Re: Initial Submission Review – Landmark at Town Center – Site Plan and Final Plat
Application Number: **DA-1594-11**
Case Number: **2001-7010-03**

Initial Submission Review

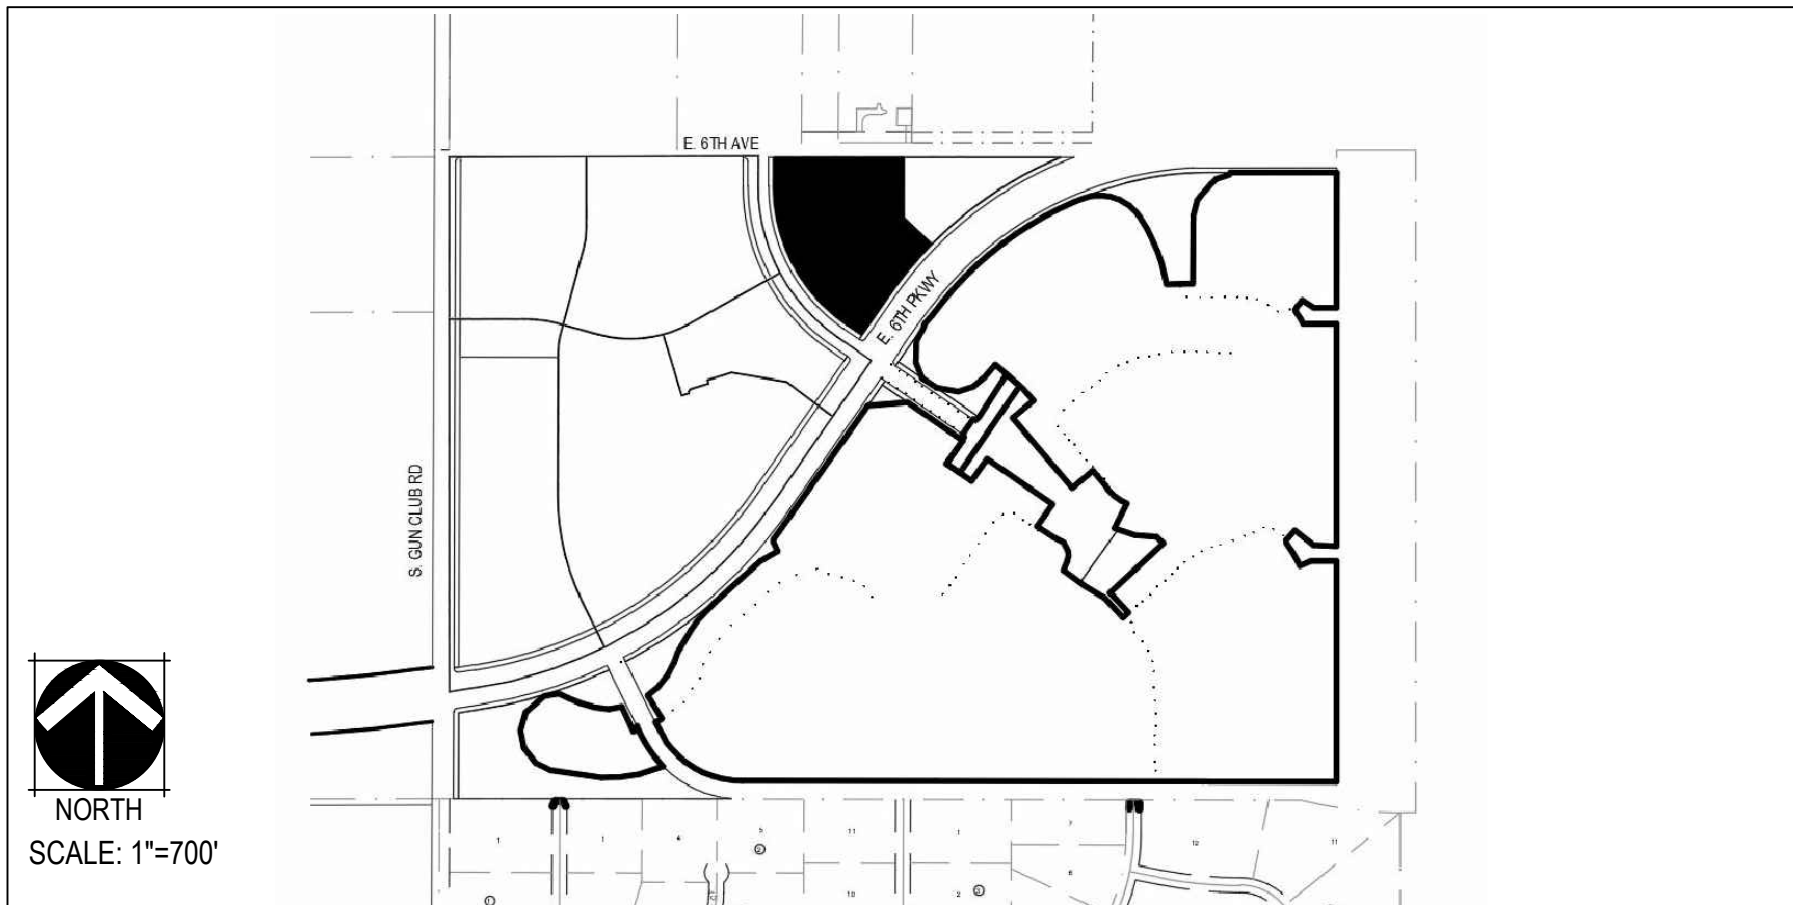
parking spaces
(5% of the total
required
parking).

Response: Parking has
been updated.

SHEET TITLE:
COVER SHEET

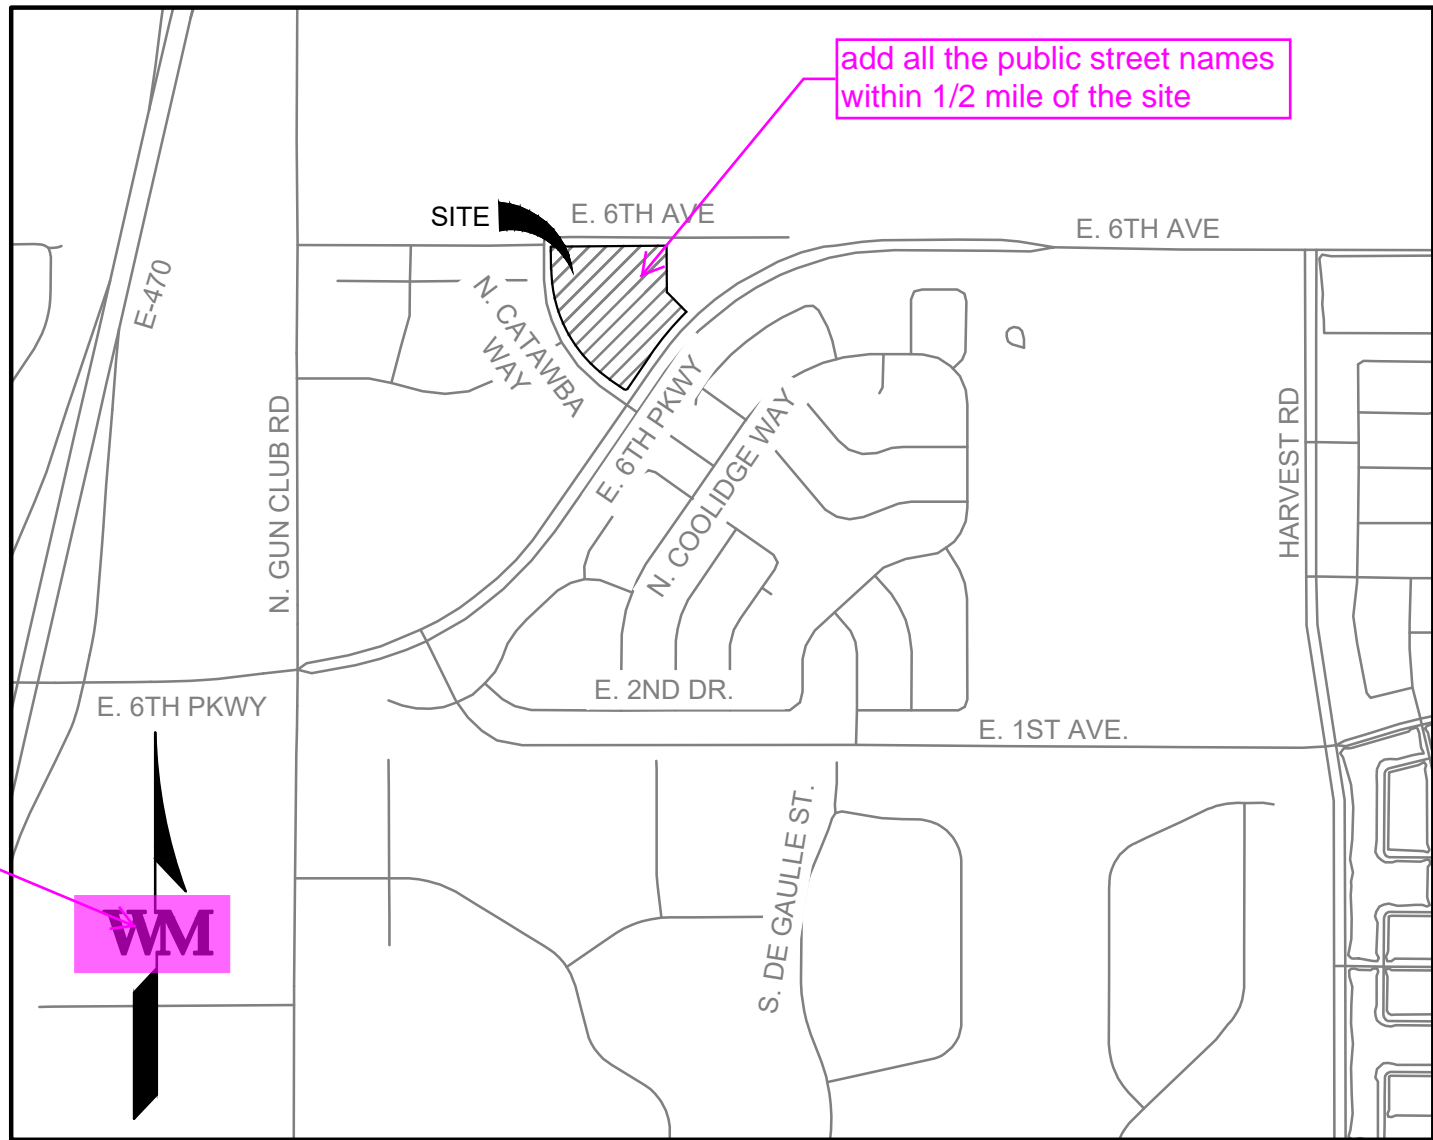
Add an amendments block to this sheet.

Response: Block has been added.

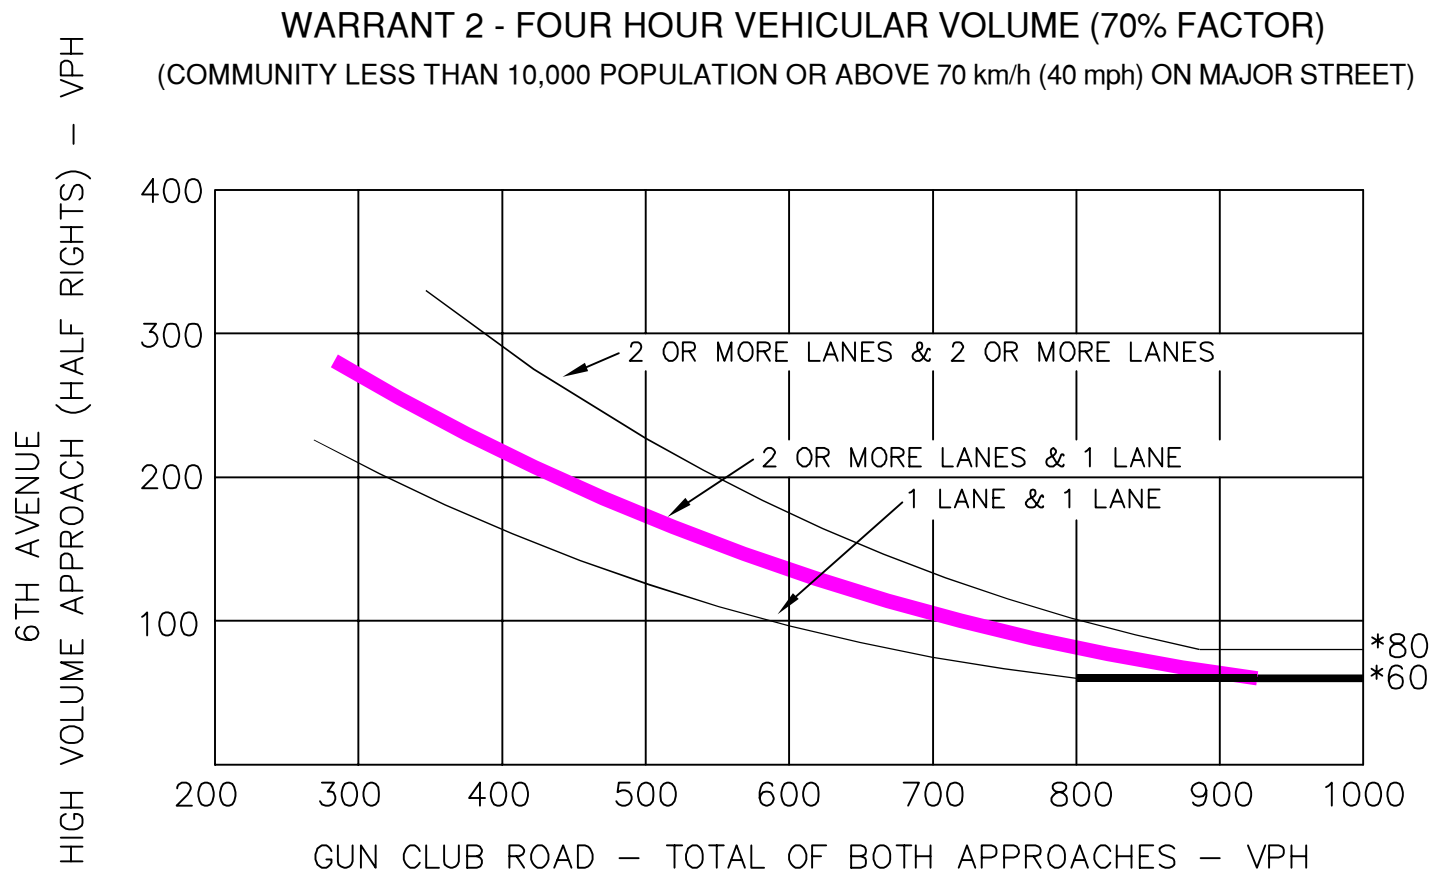
add CDOT Access Code lengths for all movements

The CDOT Access Code lengths were added to the table in the revised study.
